TBS BIHeli-S DShot 600

D-Shot ESC update January 2017

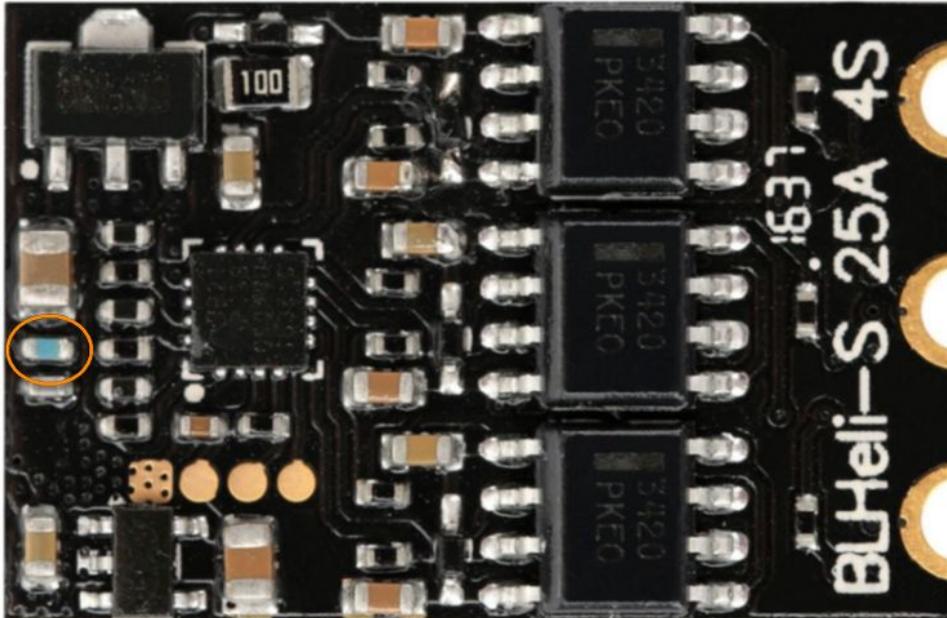
DShot and especially their fastest version called Dshot 600 requires such fast and steep signal that the filter irons out the entire input signal.

By removing the “C”apacitor from the RC filter the filter can be disabled. This requires really clean wiring of the PWM signal on the drone and enough distance from any noisy source (battery traces, DCDC regulators etc.). This requirement is not unique to the TBS ESC, any ESC with Dshot600 enabled will not have adequate filtering for EMI, in our opinion. Lack of filtering may result in distorted signals and then the ESC does not receive control from the FC anymore, resulting in undesirable behavior.

Modification is fairly easy, it requires to remove the Capacitor shown on picture below, marked with red circle. Modification is done on your own risk.

In any case you want to undo the modification, the Capacitor is:
"470pF, 50V, 0402, 5%"
